Access Compliance Report

Public Rights-of-Way

(Curb Ramps)

Intersection ID: 29218	Main Street: ANASTASIA_CT	Cross Street: KORNIV_DR	Location:	N
ADA ID: 287A52AC8A13	Ramp Type: PerpDiag	Initial Pass/Fail: Fail	Overall Compliance: No	Severity Score: 37.5

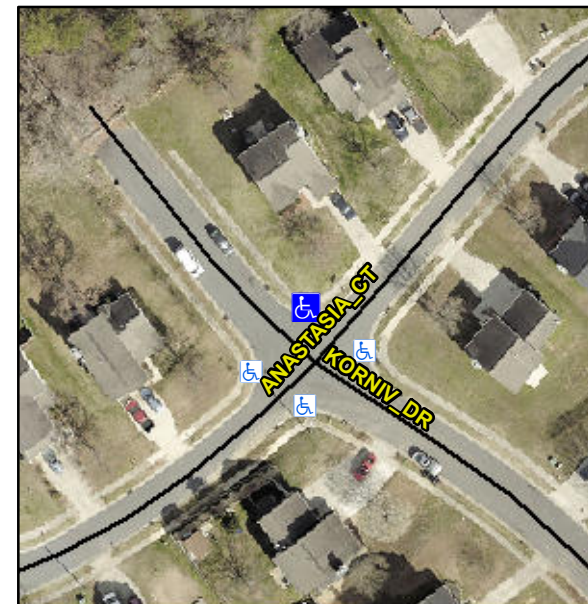
R304.2.2, R304.5.3

Compliance	Description	Data	Compliance	Description	Data
N/A	Ramp Length (in)	48.0	No	Ramp Slope (%)	8.9
Yes	Ramp Width (in)	48.0	No	Ramp XSlope (%)	9.2
N/A	Flare Type LT	N/A	N/A	Flare Type RT	N/A
N/A	Flare Slope LT (%)	N/A	N/A	Flare Slope RT (%)	N/A
N/A	Flare Traversable LT?	N/A	N/A	Flare Traversable RT?	N/A
N/A	Landing Length (in)	N/A	N/A	DWS Provided?	N/A
N/A	Landing Width (in)	N/A	N/A	DWS Contrast?	N/A
N/A	Landing Slope (%)	N/A	N/A	DWS Length (in)	N/A
N/A	Landing X Slope (%)	N/A	N/A	DWS Full Width?	N/A
N/A	Landing Curb? (Y/N)	N/A	N/A	DWS Offset (in)	N/A
N/A	Shared Landing?	N/A			
N/A	Gutter Ponding?	N/A	N/A	Gutter Slope (%)	N/A
N/A	Gutter Lip Ht (in)	0.5	N/A	Gutter X Slope (%)	N/A
N/A	Painted X Walk1?	No	N/A	Painted X Walk2?	No
	X Walk 1 Direction	To SW		X Walk 2 Direction	To SE
N/A	X Walk 1 Width (in)	N/A	N/A	X Walk 2 Width (in)	N/A
	X Walk 1 Slope (%)	1.7		X Walk 2 Slope (%)	11.0
	X Walk 1 X Slope (%)	10.5		X Walk 2 X Slope (%)	0.6

Remove & Replace Curb Ramp With Two New Directional Ramps or Equivalent.
